CU Anschutz – Breckenridge Parking Lot Improvements

Project Number: 22-116457

Thursday, June 30, 2022
ADDENDUM 3

ED-102

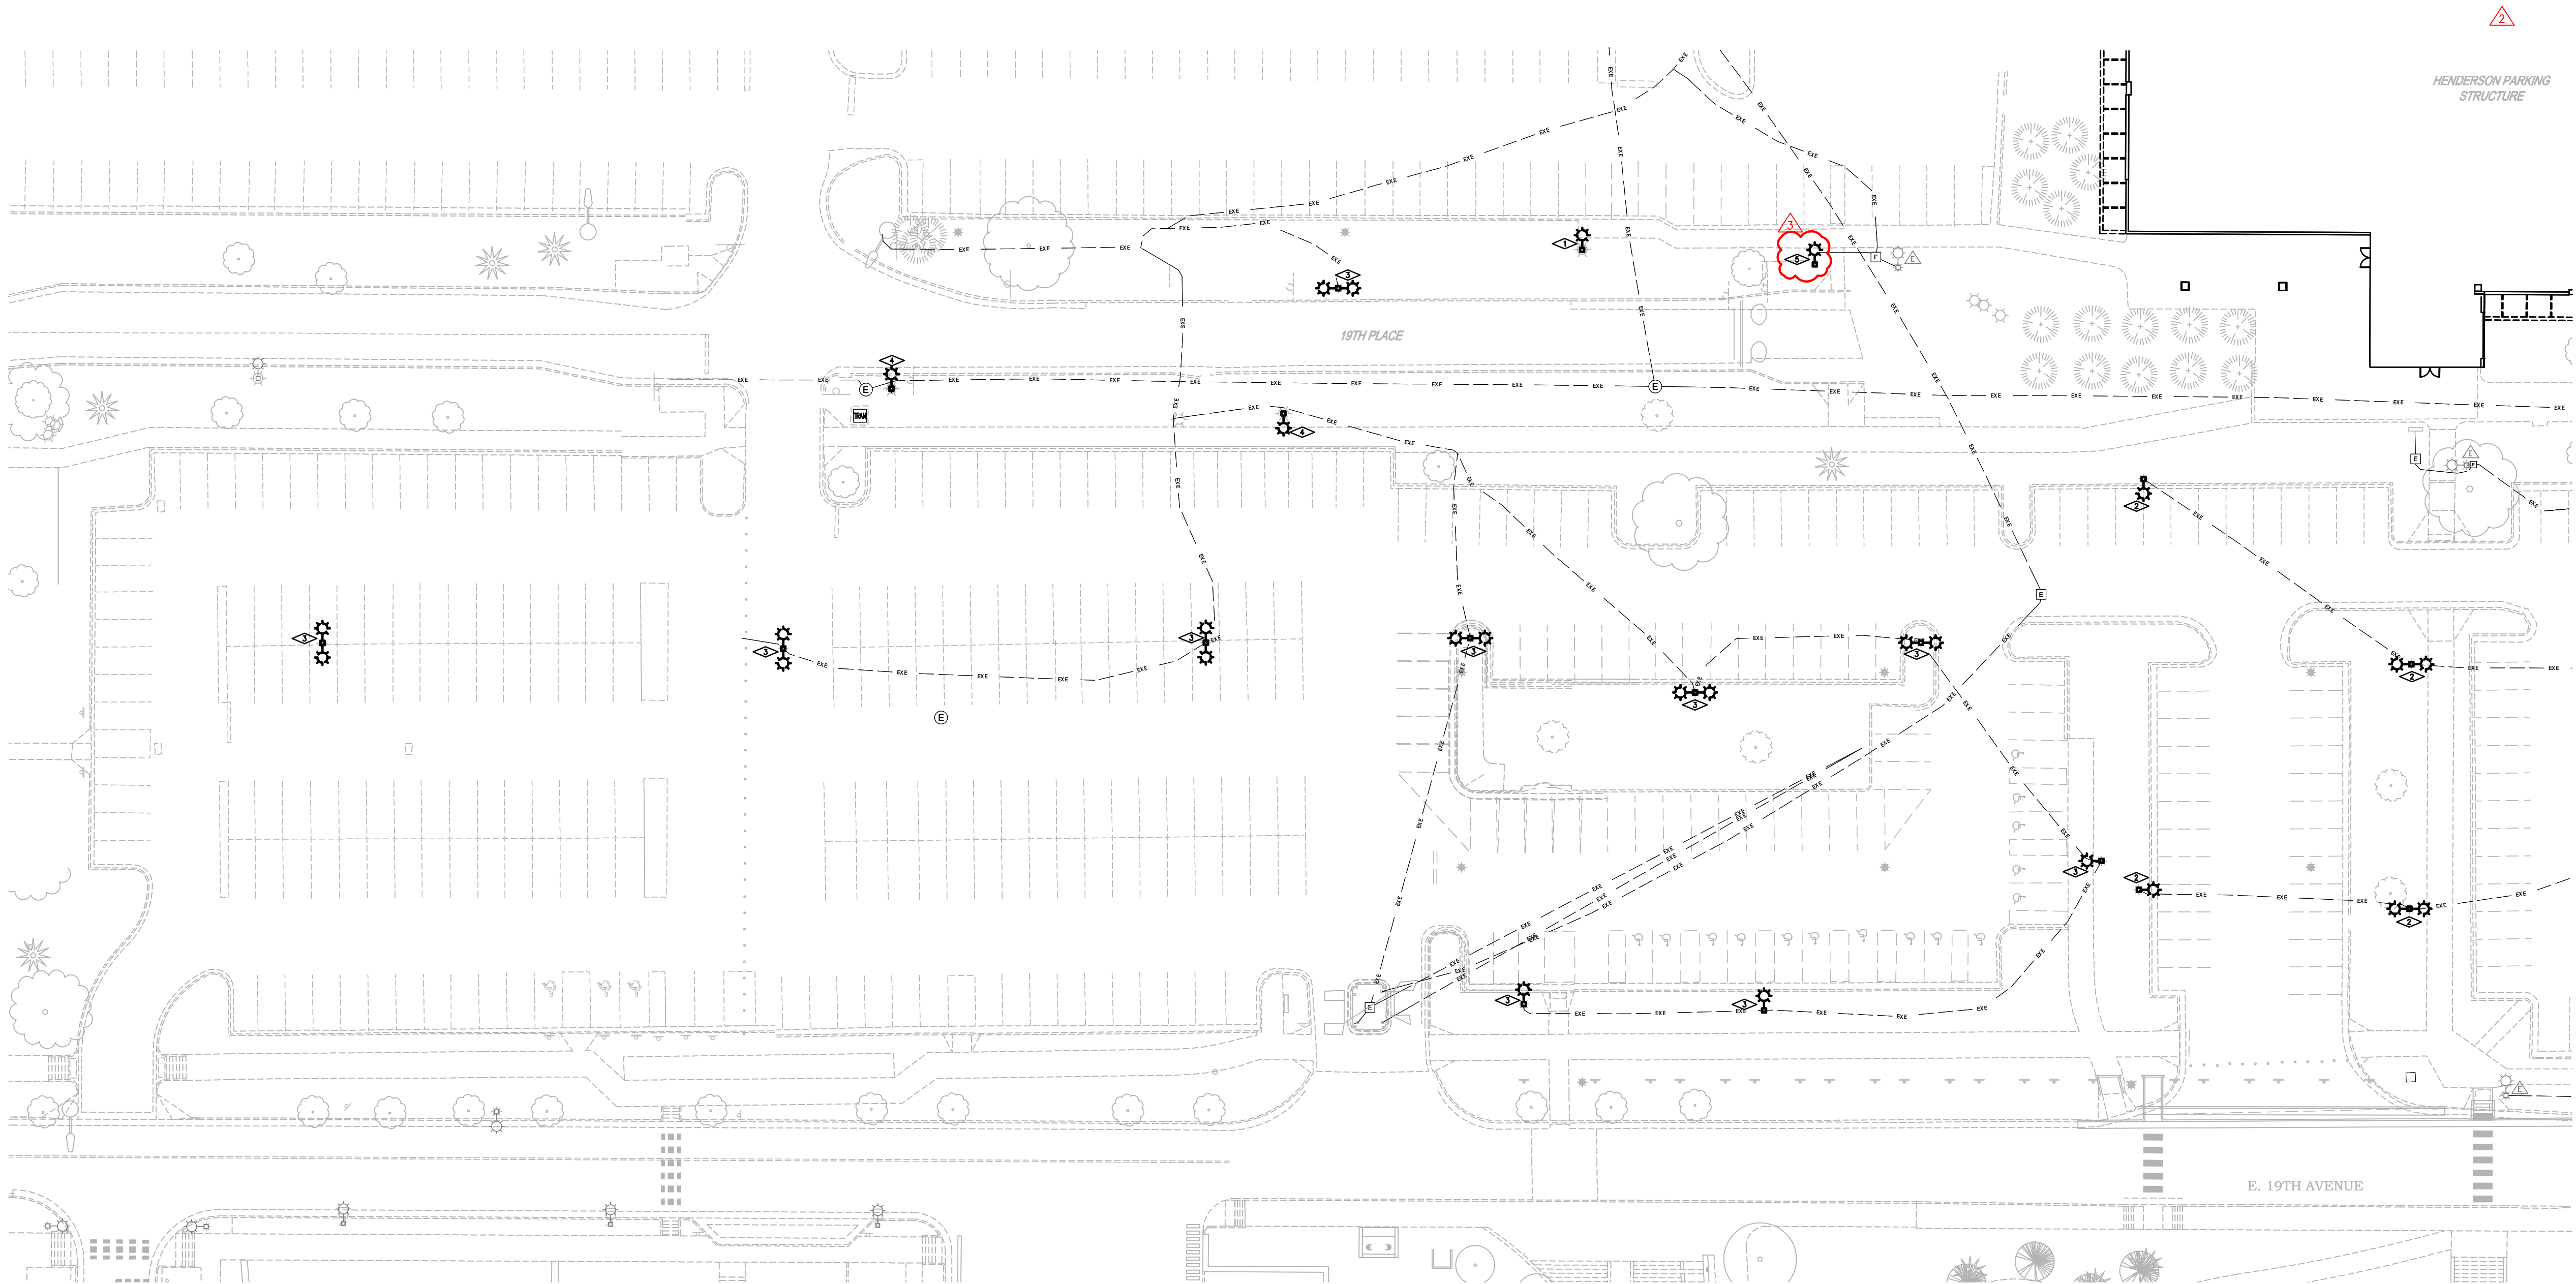
1. The following sheets have been revised to reflect an enlarged parking/snow storage area as a part of Add-Alternate 2:
 - a. C-101
 - b. C-121
 - c. C-211
 - d. C-411
 - e. C-421
 - f. C-452
 - g. C-511
 - h. ED-102
2. The following sheets have been revised to reflect comments from Pete Bloomquist, more specifically:
 - a. E-001: Removed house side shield from Luminaire Schedule and updated voltage to be Universal.
 - b. E-102: Circuit information added, revised keynotes
 - c. E-103: Circuit information added, revised keynotes

1. EXISTING POLE TO REMAIN. HEAD TO BE ROTATED. REFER TO NEW LIGHTING PLAN SHEET E-102 FOR ADDITIONAL INFORMATION.
2. POLE AND LED HEAD TO BE REUSED AND RELOCATED. REFER TO NEW LIGHTING PLAN SHEET E-102 FOR ADDITIONAL INFORMATION.
3. POLE TO BE RELOCATED. HEAD/HEADS ARE TO BE UPGRADED TO LED. REFER TO NEW LIGHTING PLAN SHEET E-102 FOR ADDITIONAL INFORMATION.
4. EXISTING CORBA HEAD LIGHT FIXTURE TO BE REMOVED.
5. PEDESTRIAN POLE LUMINAIRE TO BE REMOVED IN ADD ALTERNATE #2.

E-103

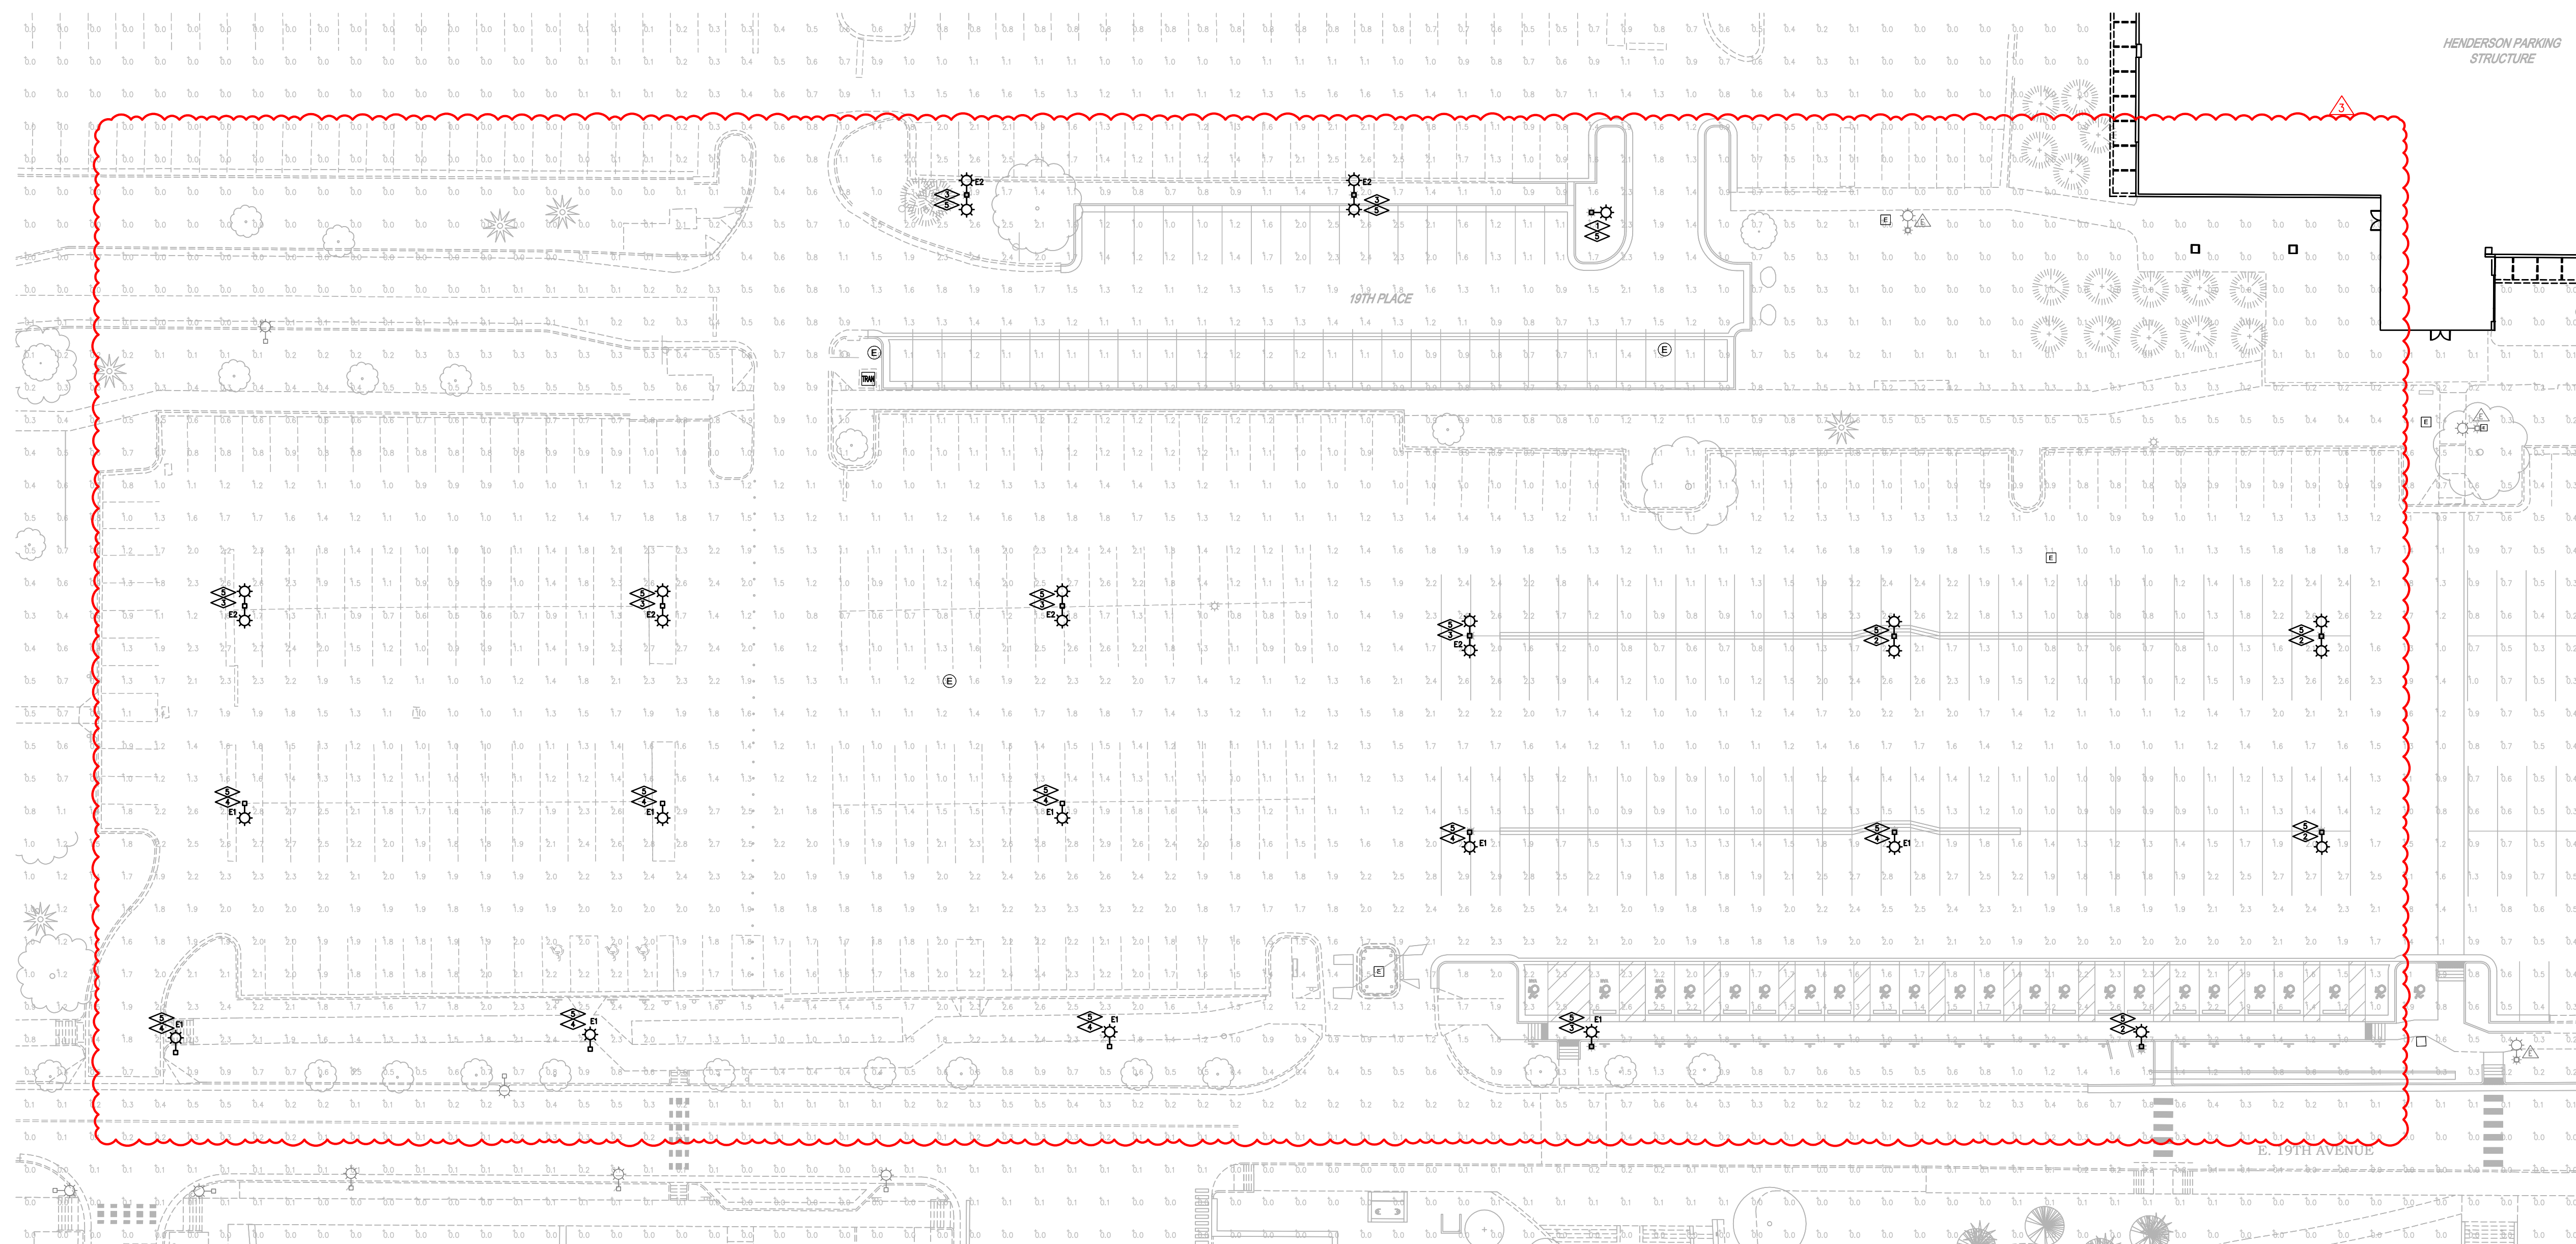
1. EXISTING POLE AND HEAD TO REMAIN. ROTATE EXISTING POLE/HEAD TO THE NEW DIRECTION SHOWN.
2. POLE AND LED HEAD TO BE REUSED AND RELOCATED.
3. POLE TO BE RELOCATED. HEAD/HEADS ARE TO BE UPGRADED TO LED. REFER TO LUMINAIRE SCHEDULE FOR MORE INFORMATION.
4. NEW POLE AND NEW LED HEAD TO BE PROVIDED. REFER TO LUMINAIRE SCHEDULE FOR MORE INFORMATION.
5. ALL LUMINAIRES IN THE BRECKENRIDGE PARKING LOT SHALL BE CONNECTED TO THE SAME EXISTING LIGHTING CONTROL SYSTEM AND LIGHTING CIRCUIT. CONNECT/RECONNECT TO EXISTING LCP-W17. CIRCUIT IDENTIFICATION LABELS SHALL BE AFFIXED TO EACH POLE ABOVE THE HAND HOLE.
